# UNITED STATES PATENT AND TRADEMARK OFFICE

APPLICATION NO.	FILING DATE	FIRST NAMED INVENTOR	ATTORNEY DOCKET NO.	CONFIRMATION NO.
10/728,783	12/08/2003	Kia Silverbrook	MTB09US	1040

<b>Office Action Summary</b>	<b>Application No.</b> 10/728,783	<b>Applicant(s)</b> SILVERBROOK, KIA	
	<b>Examiner</b> shih-wen hsieh	<b>Art Unit</b> 2861

Silverbrook teaches in his fig. 4 (shown below):

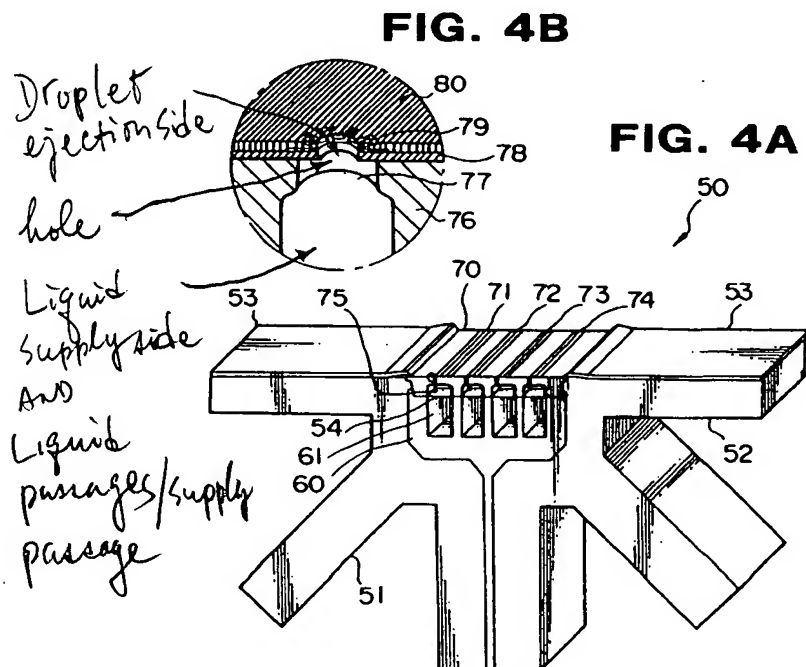
An inkjet print head (50) comprising: a monolithic wafer (76) having a droplet ejection side (refer to fig. above) and a liquid supply side (refer to fig. above); a plurality of nozzles (77); droplet ejection actuators (79, heater element) and associated drive circuitry (drive circuitry is inherently associated with the heater elements in a bubble jet printer) corresponding to each nozzle respectively, the nozzles, ejection actuators and associated drive circuitry being formed on the droplet ejection side; and a plurality of liquid passages (see fig. above) extending from the droplet ejection side to the liquid supply side for supply each of the nozzles with liquid; wherein, each of the liquid passages is formed by a hole (see fig. above) extending from the droplet ejection side partially through the monolithic wafer and a supply passage (see fig. above) extending from the liquid supply side partially through the monolithic wafer such that a fluid connection is established with the hole, the supply passage being wider than the hole, refer to col. 3, line 63 to col. 4, line 28.

a plurality of nozzle chambers (see fig. above), each nozzle chamber corresponding to a respective nozzle; wherein at least one the of the gas bubble generating heater elements are disposed in each of the nozzle chambers respectively;

such that, a bubble forming liquid can be supplied to the nozzle chamber for thermal contact with at least one of the bubble generating heater elements so that a bubble of the bubble forming liquid generated by one of the heater elements causes a droplet of the ejectable liquid to be ejected from the nozzle, refer to col. 1, lines 36-43 and fig. 2.

An up-to-date search a reference US 5,815,173 is found and was used in this office action. Examiner believes the configuration of fig. 4 read on the instant application.
